## Supplement to the proposal for 04 series of amendments to Regulation No. 12

The text reproduced below was prepared by the expert from France in order to extend the scope of the present Regulation to all kinds of power train systems above a certain working voltage level. The modifications to the existing text of the Regulation R 12 are based on informal document No. GRSP- 46-04, distributed during the forty sixth session of the Working Party on Passive Safety (GRSP) and discussions made at the 3<sup>rd</sup> EVPC adhoc group meeting held in Bonn, 11-12 march 2010. This informal document supersedes document ECE/TRANS/WP.29/GRSP/2010/19 distributed as an official document for the forty-seventh session of the Working Party on Passive Safety (GRSP). The modifications to the existing text of Regulation No. 12 are originally marked in bold or strikethrough characters and the modifications resulting form the EVPC meeting are highlighted in grey colour.

**Figure 1:** Measurement of  $V_b$ ,  $V_1$ ,  $V_2$ ,  $V_3$

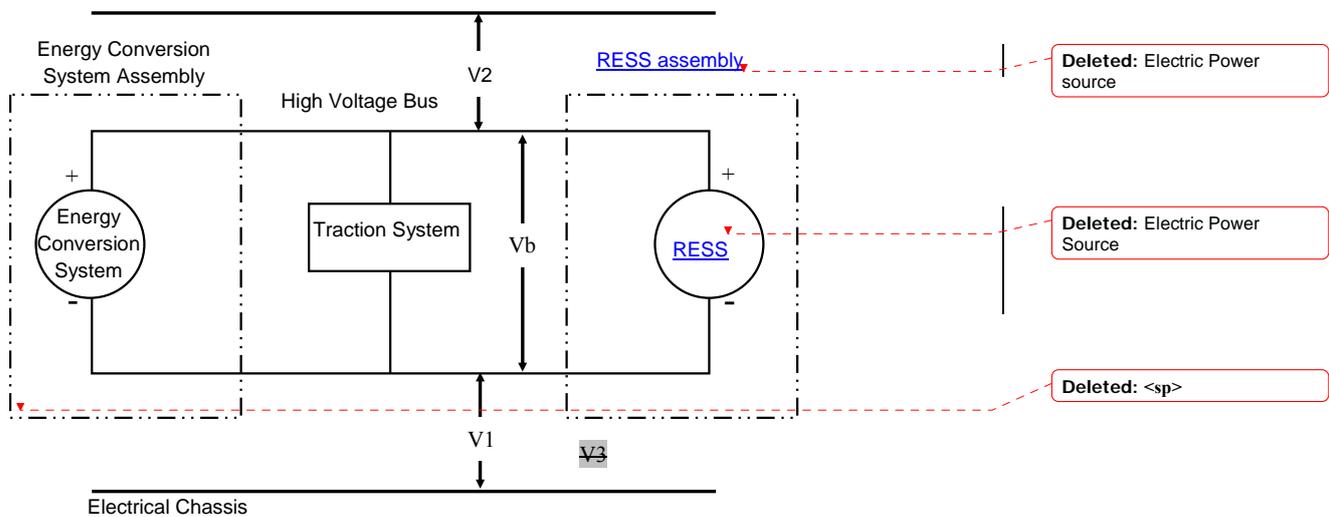
After the impact ~~crash~~-test, determine the high voltage bus voltages ( $V_b$ ,  $V_1$ ,  $V_2$ ) (see figure 1). ~~If the RESS has exposed conductive parts, measure the voltage  $V_3$  between any exposed conductive parts of it and the electrical chassis.~~

The voltage measurement shall be made not earlier than 5 seconds but not later than 60 seconds after the impact.

**Figure 2:** E.g. Measurement of high voltage bus energy stored in X-capacitors

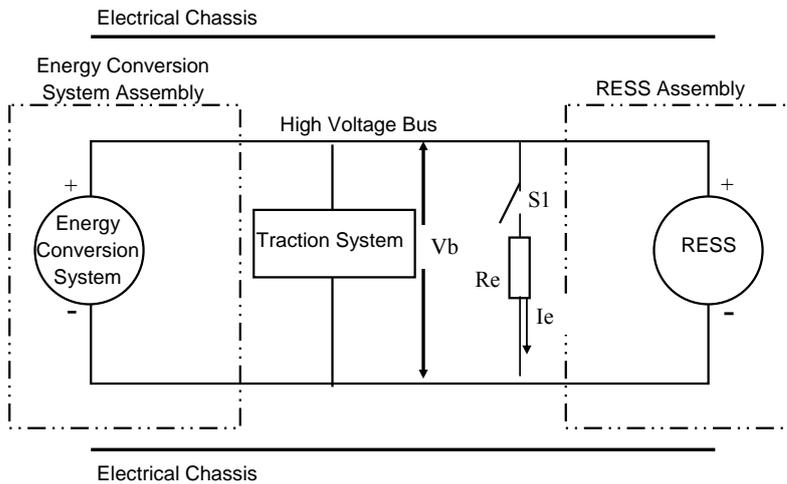
Prior to the impact a switch  $S_1$  and a known discharge resistor  $R_e$  is connected in parallel to the relevant capacitance (ref. figure 2). ~~installed according to figure 2.~~

Not earlier than 5 seconds and not later than 60 seconds ~~At 5 seconds~~ after the impact the switch  $S_1$  shall be ~~is~~ closed while the voltage  $V_b$  and the current  $I_e$  are ~~is~~ measured and recorded. The product of the voltage  $V_b$  and the current  $I_e$  shall be ~~is~~ integrated over the period of time, starting from the moment when the switch  $S_1$  is closed ( $t_c$ ) until the voltage  $V_b$

**Figure 1: Jointed test finger**

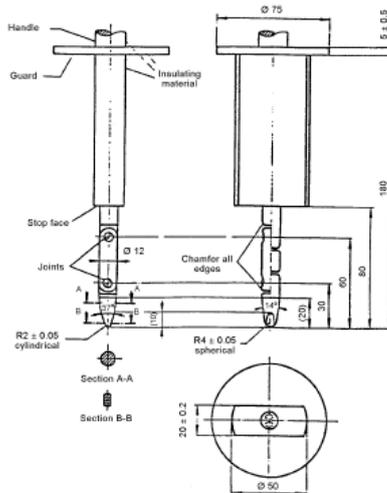
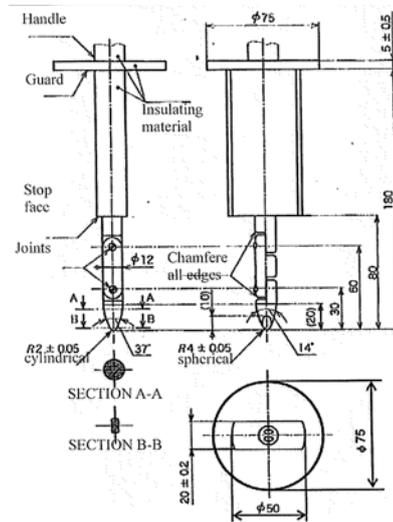
The Jointed Test Finger ~~access probe~~ described in Appendix 1 figure 1 is ~~pushed against~~ shall be inserted into any gaps or openings of the ~~original~~ physical protection with a ~~the~~ test force of  $10\text{ N} \pm 10\text{ per cent}$  for electrical safety assessment. If partial or full penetration ~~it partly or fully penetrates~~ into the ~~original~~ physical protection by the Jointed Test Finger occurs, ~~it is~~ the Jointed Test Finger shall be placed in every ~~possible~~ position as specified below.

Starting from the straight position, both joints of the test finger shall be rotated progressively ~~successively bent~~ through an angle of up to 90 degrees with respect to the axis of the adjoining section of the finger and shall be placed in every possible position.
